P802.3bt D3.0 – Mark & Hold v111

Mark & Hold allows a PSE to remain in the mark state for an indefinite amount of time, provided it checks that the PD draws a valid mark current. See full proposal and rationale ➔lukacs_01_0517

Figure 145–13 — Top level PSE state diagram

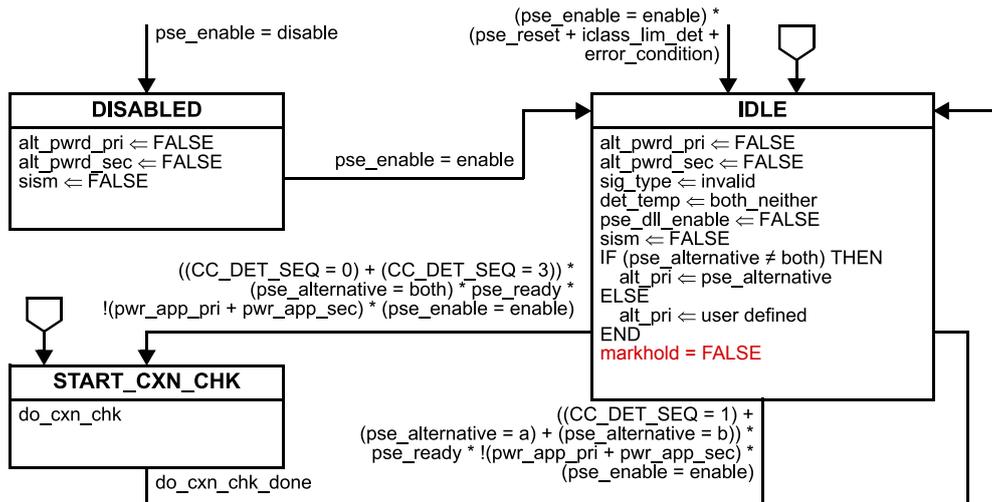
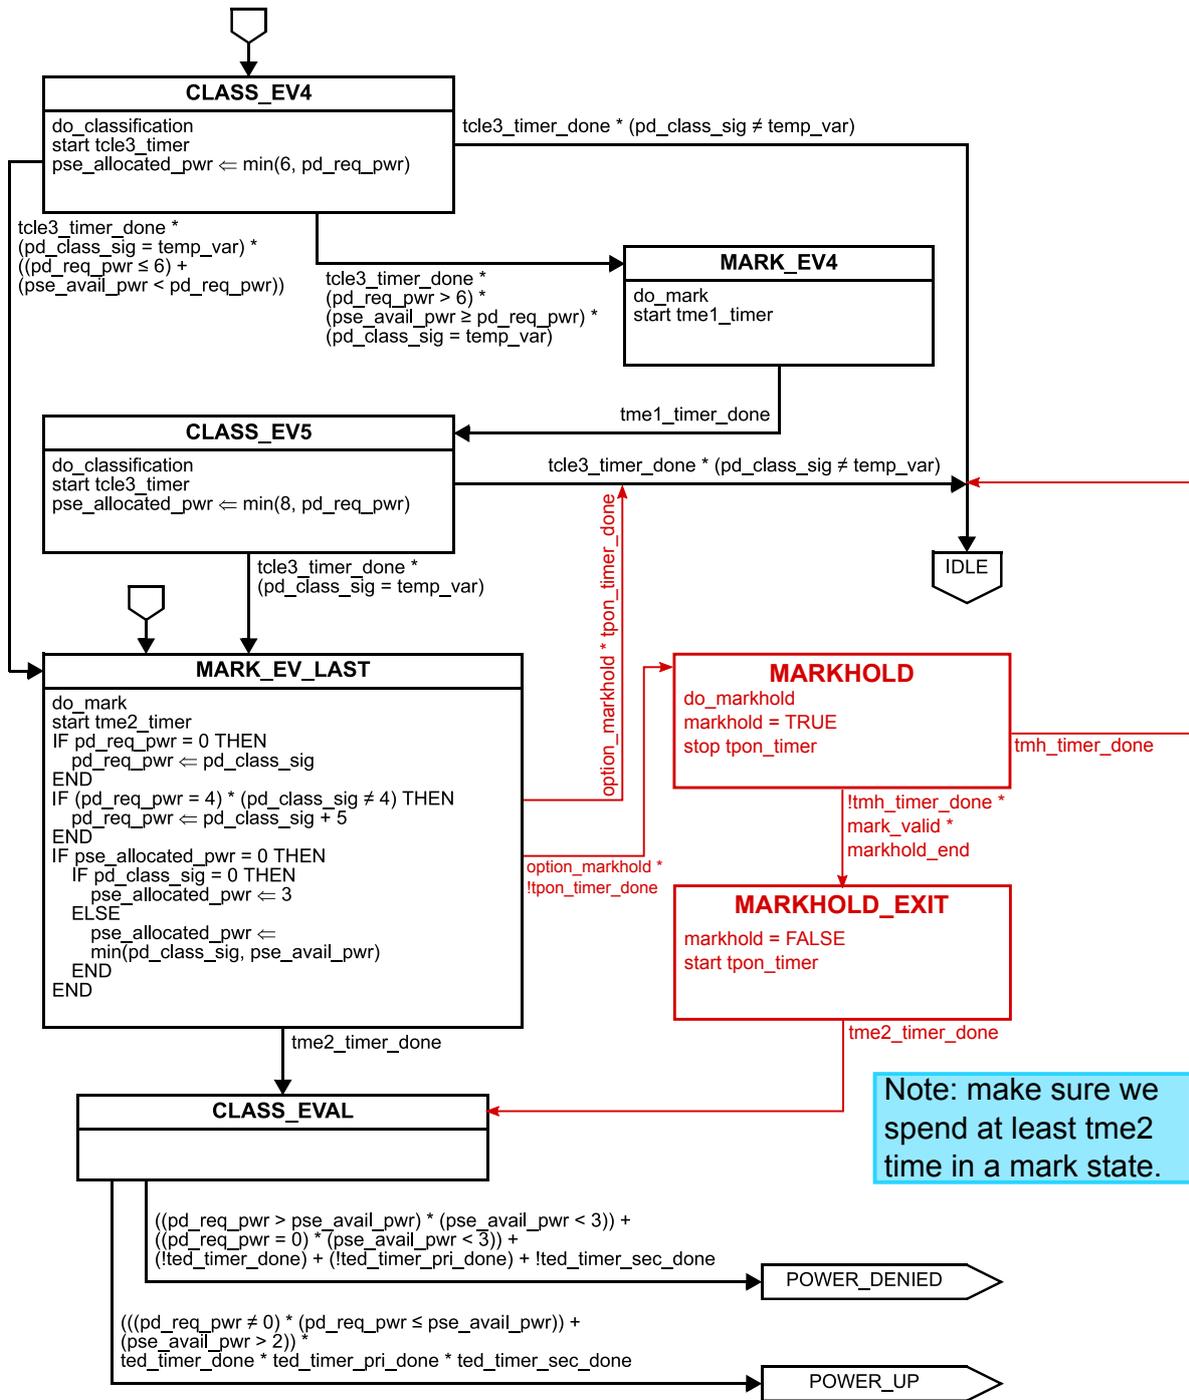
Change Figure 145–13 as follows:

Note: make sure we spend at least tme2 time in a mark state.

Figure 145–15 — Primary Alternative dual-signature semi-independent PSE state diagram (continued)

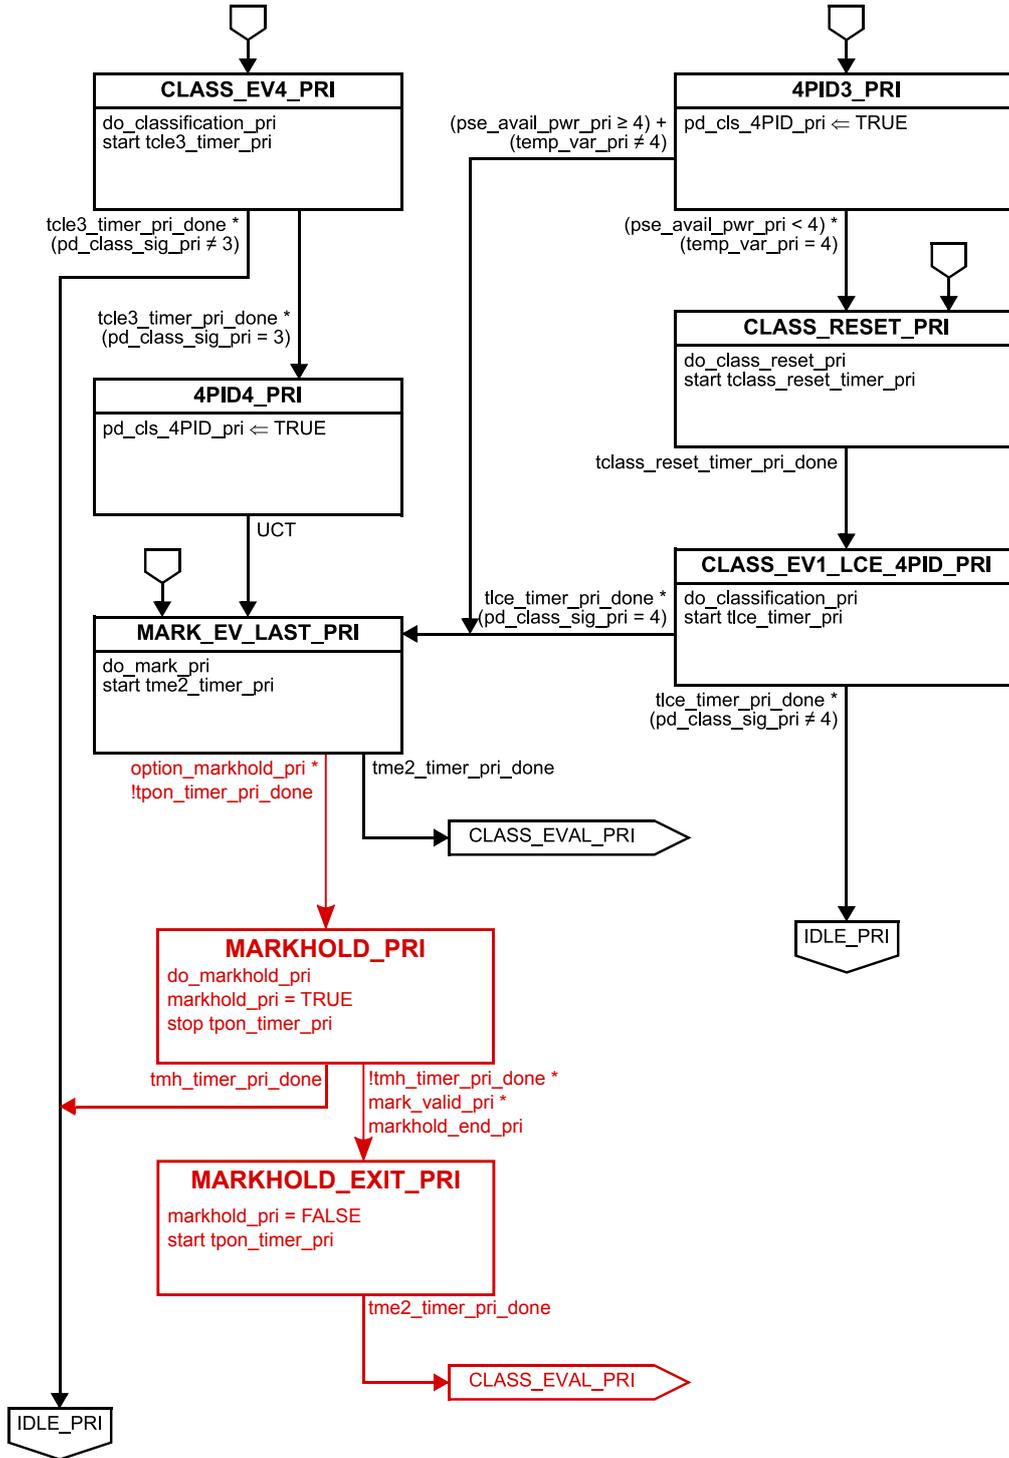
Change Figure 145–15 as follows, change Figure 145–16 in the same way for Secondary:

Figure 145–16a — PSE mark monitor state diagram for single-signature PDs or 2-pair operation

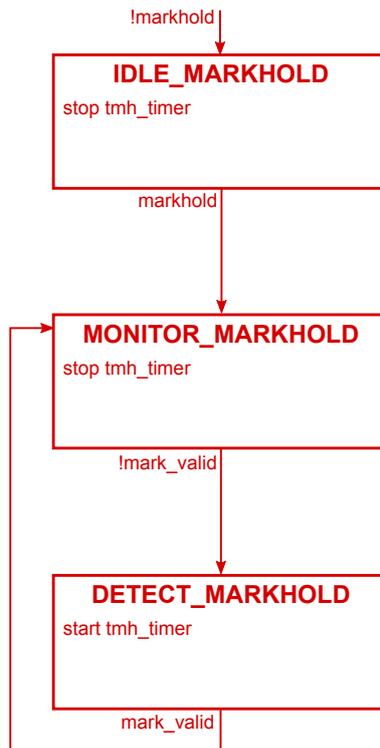
Add a new Figure before 145–17 as follows:

Figure 145–16b — PSE mark monitor state diagram for dual-signature PDs

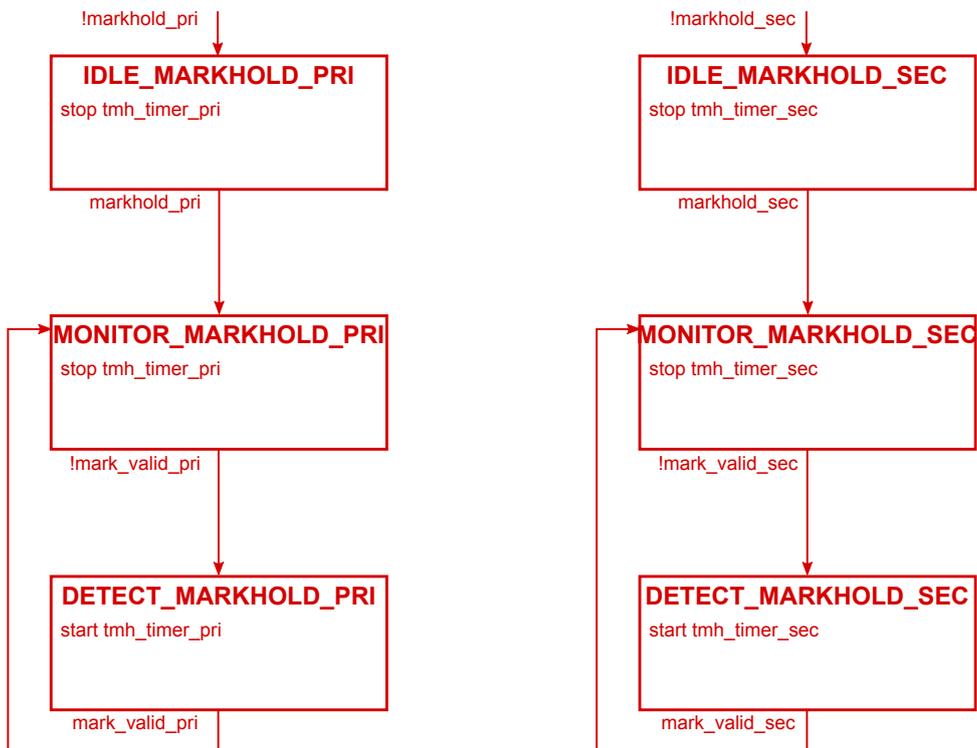
Add a new Figure after 145–16a as follows:
